PCN EE-QR-221208-01

Details of Change:

7mm×7mm 0.5mm pitch 48pin LFQFP package outline(RSB)

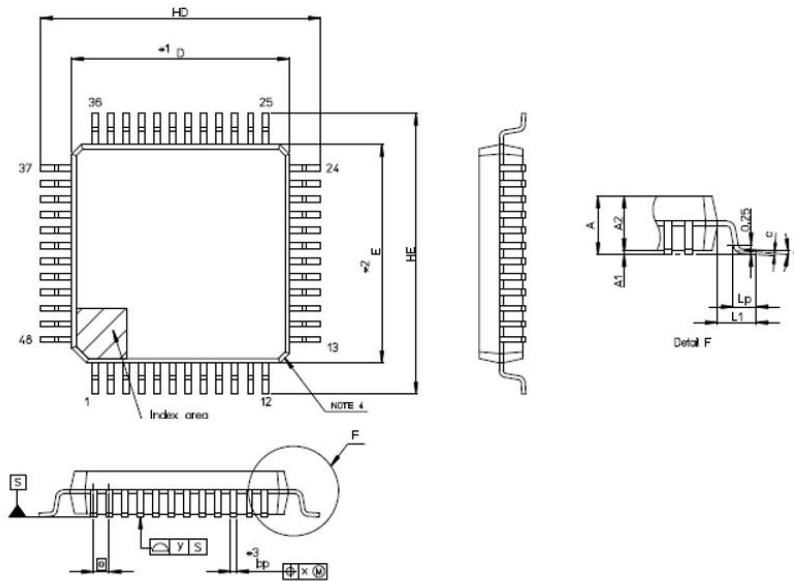
Comparison: 7mm×7mm 0.5mm pitch 48pin LFQFP package

Greatek package symbols comply JEDEC standard.

Greatek Symbol	7x7mm 48pin LQFP PLQP0048KL-A			RSB Symbol	7x7mm 48pin LQFP PLQP0048KB-B		
	Dimension in Millimeters				Dimension in Millimeters		
	Min	Nom	Max		Min	Nom	Max
A	-	-	1.60	A	-	-	1.70
A1	0.05	-	0.15	A1	0.05	-	0.15
A2	1.35	1.40	1.45	A2	-	1.40	-
D	-	9.00	-	HD	8.80	9.00	9.20
D1	-	7.00	-	D	6.90	7.00	7.10
E	-	9.00	-	HE	8.80	9.00	9.20
E1	-	7.00	-	E	6.90	7.00	7.10
N	-	48	-	-	-	-	-
e	-	0.50	-	e	-	0.50	-
b	0.17	0.22	0.27	bp	0.17	0.20	0.27
c	0.09	-	0.20	c	0.09	-	0.20
θ	0°	3.5°	7°	θ	0°	3.5°	8°
L	0.45	0.60	0.75	Lp	0.45	0.60	0.75
L1	-	1.00	-	L1	-	1.00	-
aaa	-	-	0.20	-	-	-	-
bbb	-	-	0.20	-	-	-	-
ccc	-	-	0.08	y	-	-	0.08
ddd	-	-	0.08	x	-	-	0.08

10mm×10mm 0.5mm pitch 64pin LFQFP package outline(Gretek)

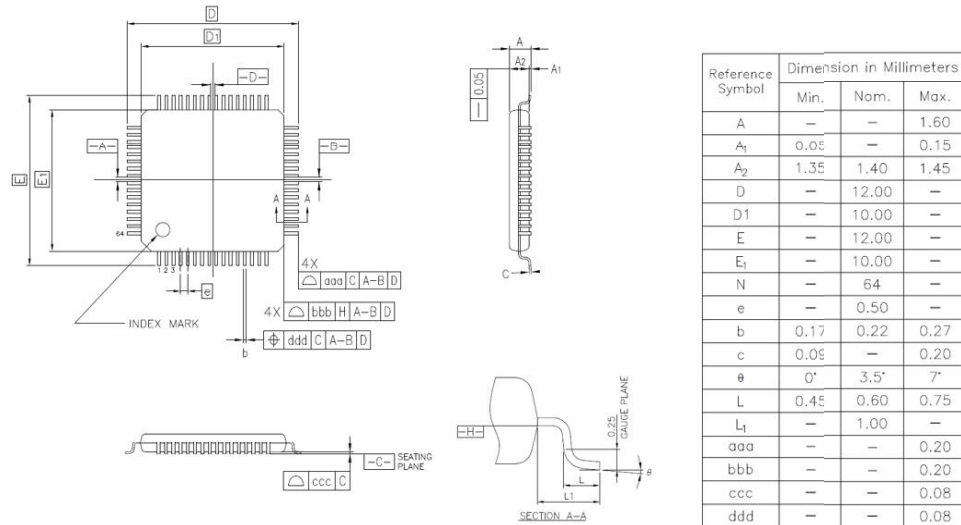
Comparison: 10mm×10mm 0.5mm pitch 64pin LFQFP package

Greatek package symbols comply JEDEC standard.

Greatek Symbol	10x10mm 64pin LQFP PLQP0064KL-A			RSB Symbol	10x10mm 64pin LQFP PLQP0064KB-C		
	Dimension in Millimeters				Dimension in Millimeters		
	Min	Nom	Max		Min	Nom	Max
A	-	-	1.60	A	-	-	1.70
A1	0.05	-	0.15	A1	0.05	-	0.15
A2	1.35	1.40	1.45	A2	-	1.40	-
D	-	12.00	-	HD	11.80	12.00	12.20
D1	-	10.00	-	D	9.90	10.00	10.10
E	-	12.00	-	HE	11.80	12.00	12.20
E1	-	10.00	-	E	9.90	10.00	10.10
N	-	64	-	-	-	-	-
e	-	0.50	-	e	-	0.50	-
b	0.17	0.22	0.27	bp	0.15	0.20	0.27
c	0.09	-	0.20	c	0.09	-	0.20
θ	0°	3.5°	7°	θ	0°	3.5°	8°
L	0.45	0.60	0.75	Lp	0.45	0.60	0.75
L1	-	1.00	-	L1	-	1.000	-
aaa	-	-	0.20	-	-	-	-
bbb	-	-	0.20	-	-	-	-
ccc	-	-	0.08	y	-	-	0.08
ddd	-	-	0.08	x	-	-	0.08
